**Amendments to the Drawings:**

**REMARKS/ARGUMENTS****1. Request for Continued Examination:**

Fig. 1

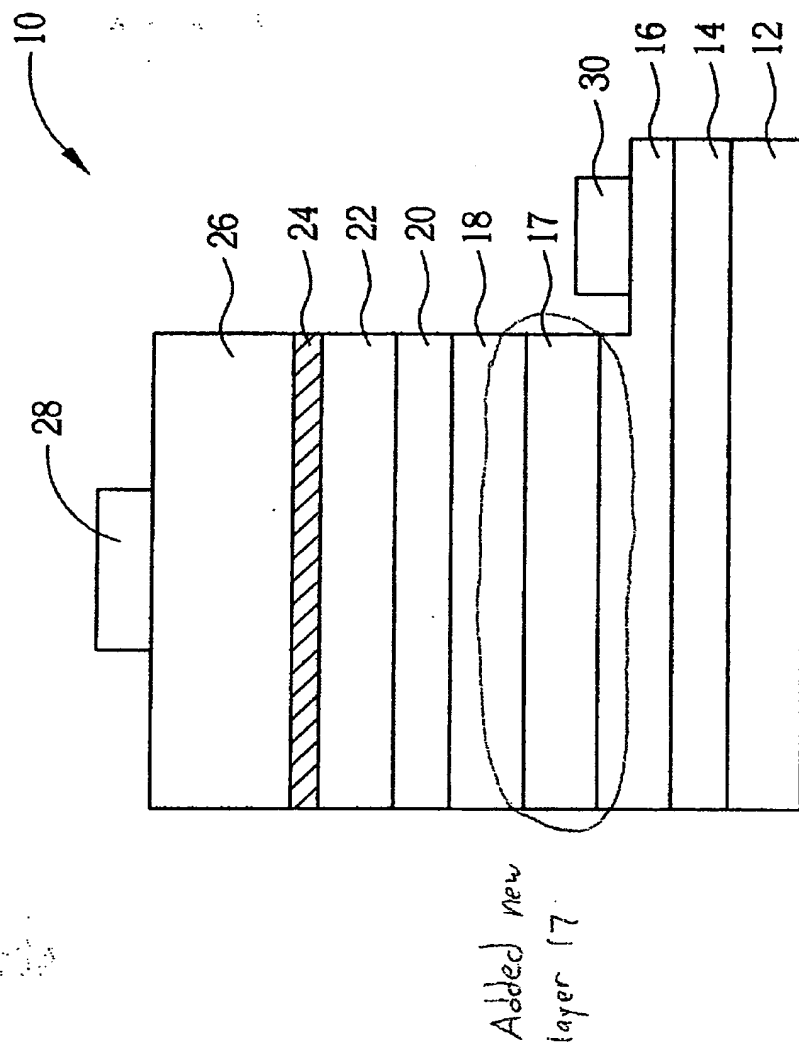
10        Claim 8 is objected to under 37 C.F.R. 1.75(d) because "the first conductivity type cladding layer" of claim 8 has not been disclosed in the remainder of the specification nor illustrated in any of the drawings. Appropriate correction is required.

Figure 1 has been amended to show the first conductivity type cladding layer recited in claim 8. As supported in the original claim 8, the first conductivity type cladding layer 17 is interposed between the first conductivity type contact layer 16 and the multiple  
5 quantum well light emitting layer 18. No new matter has been added through this amendment to Figure 1. Acceptance of the amended figure is respectfully requested.

As noted above, Fig.1 has been amended to illustrate the first conductivity type cladding layer.
